**ADDENDUM  
NO. 10**

**Greenfield Central High School Auditorium Renovation and  
Addition – Bid Package No. 2  
810 N. Broadway  
Greenfield, IN 46140**

**ADDENDUM NO. TEN**

**DATE OF ADDENDUM: JUNE 20, 2022**

**C400**

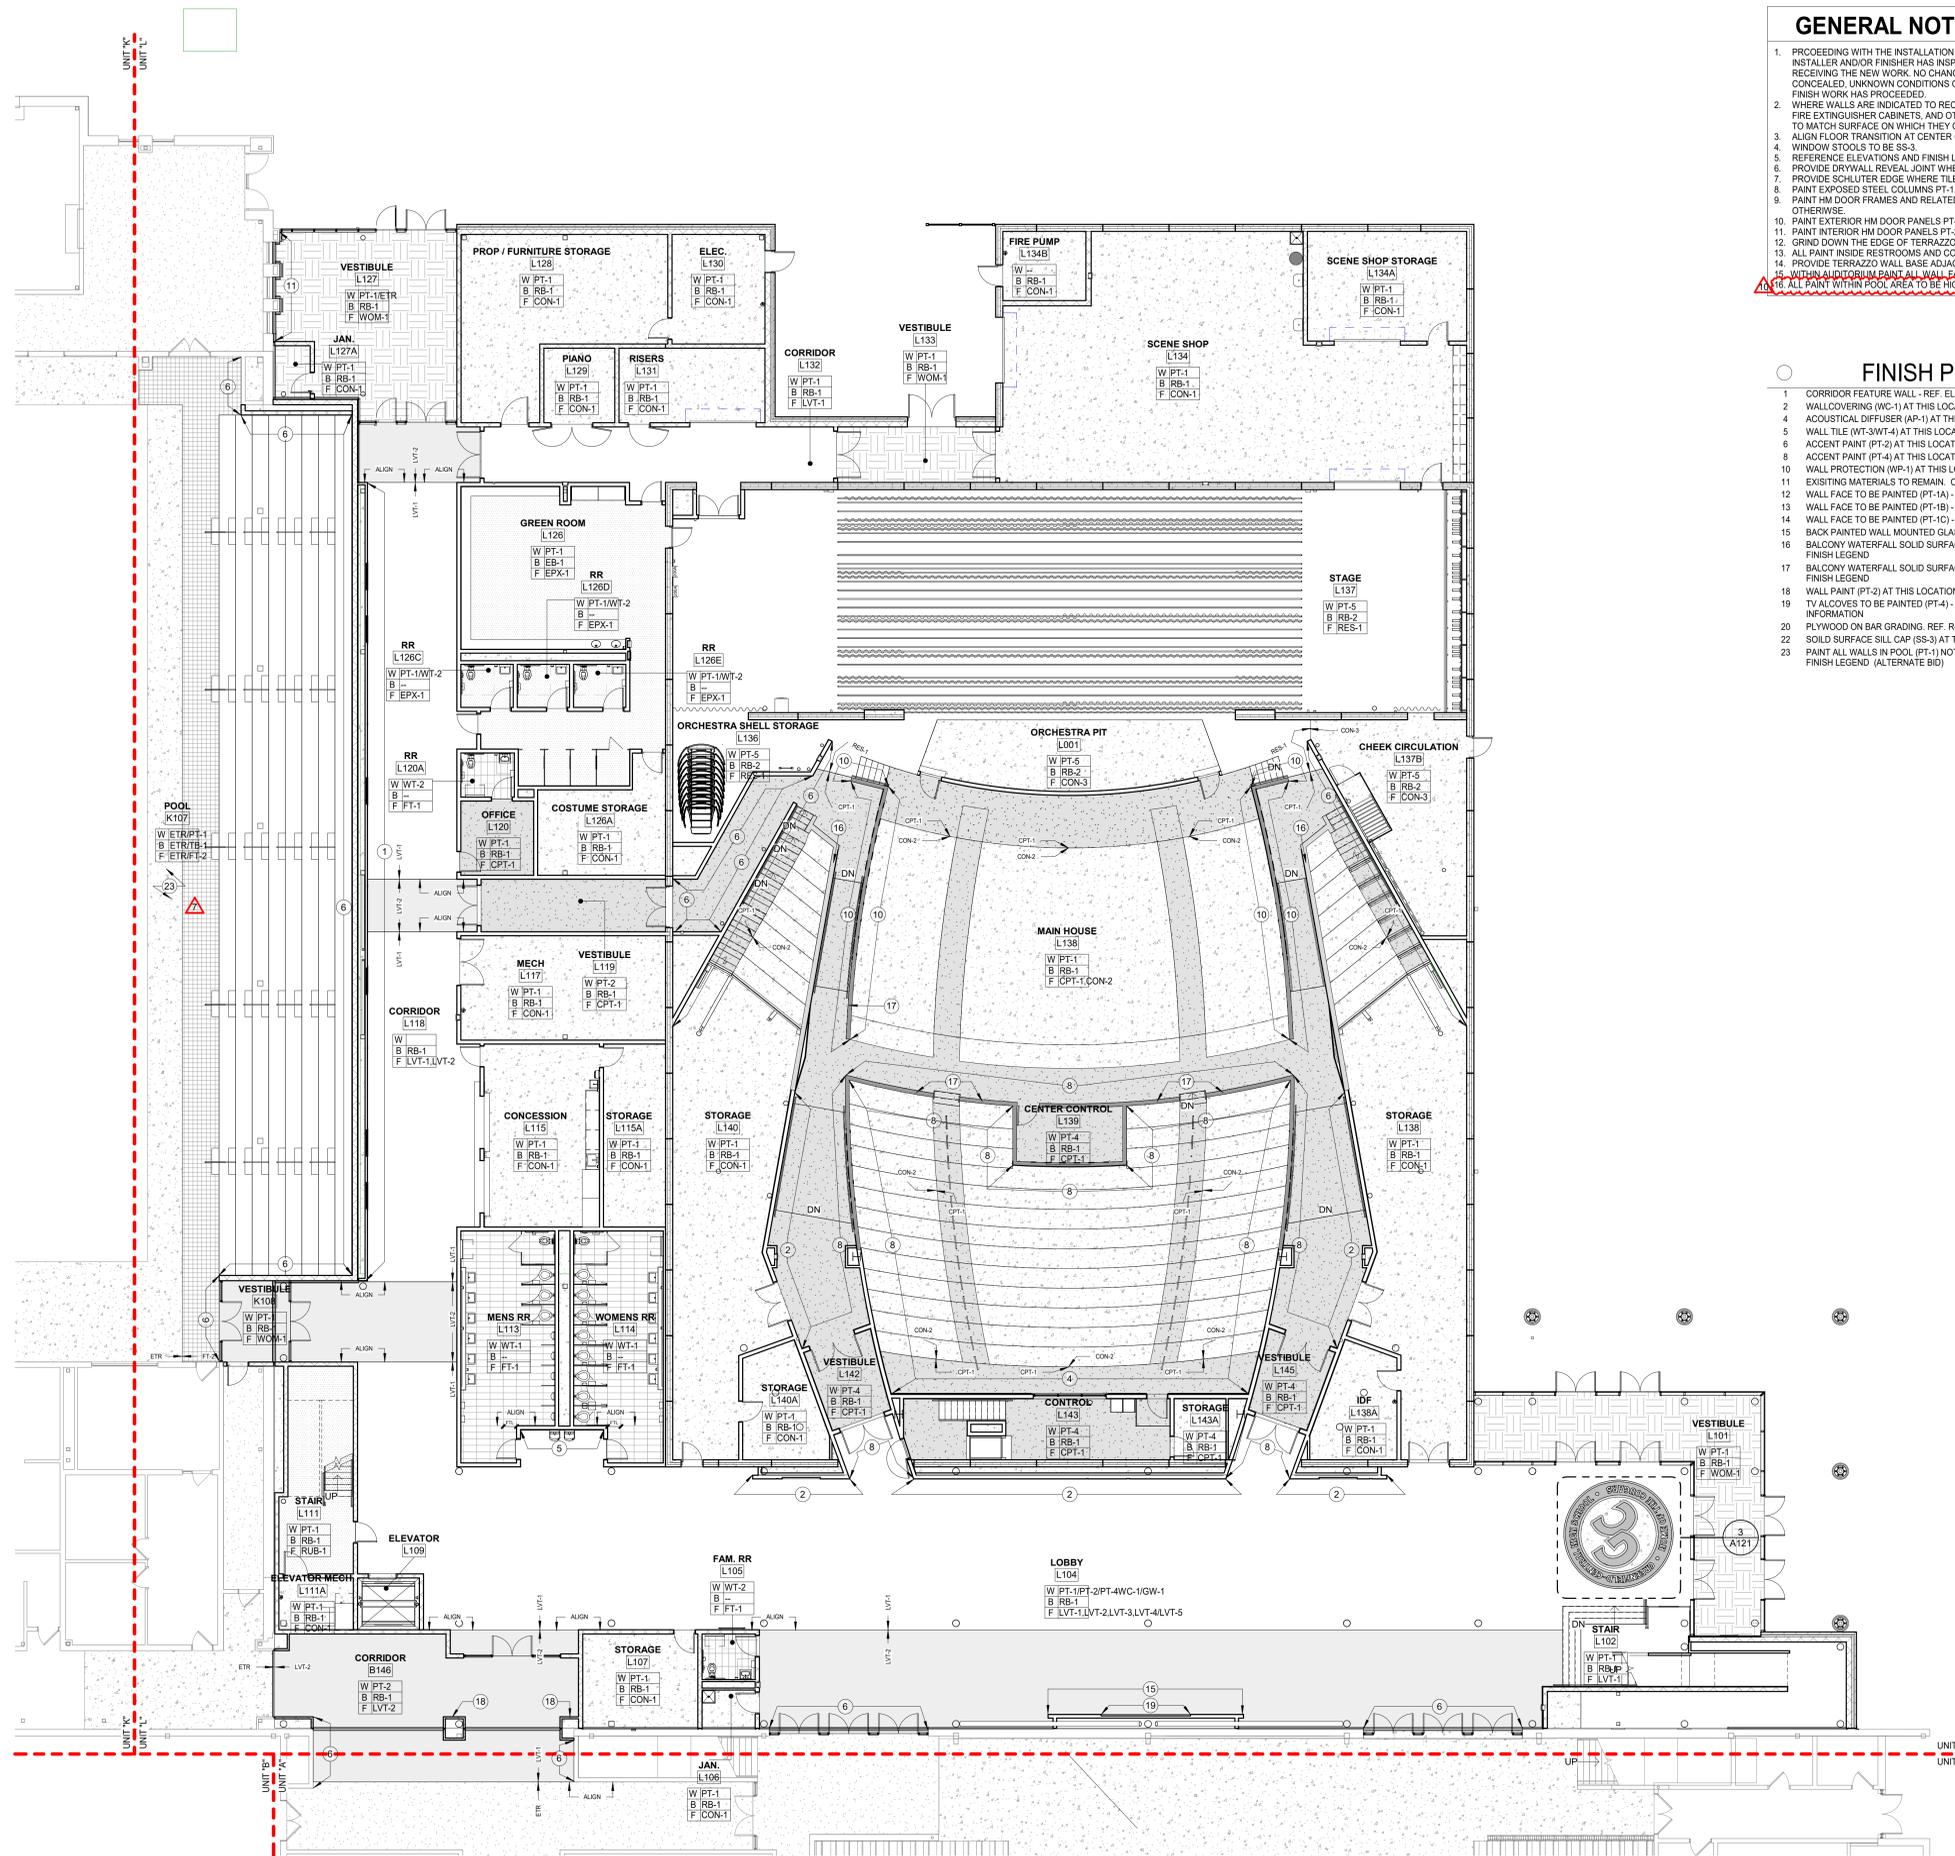
1. C400
  - ADDED DRAINAGE KEYNOTE 'D6'
  - REVISED PORTION OF DRAINAGE SYSTEM
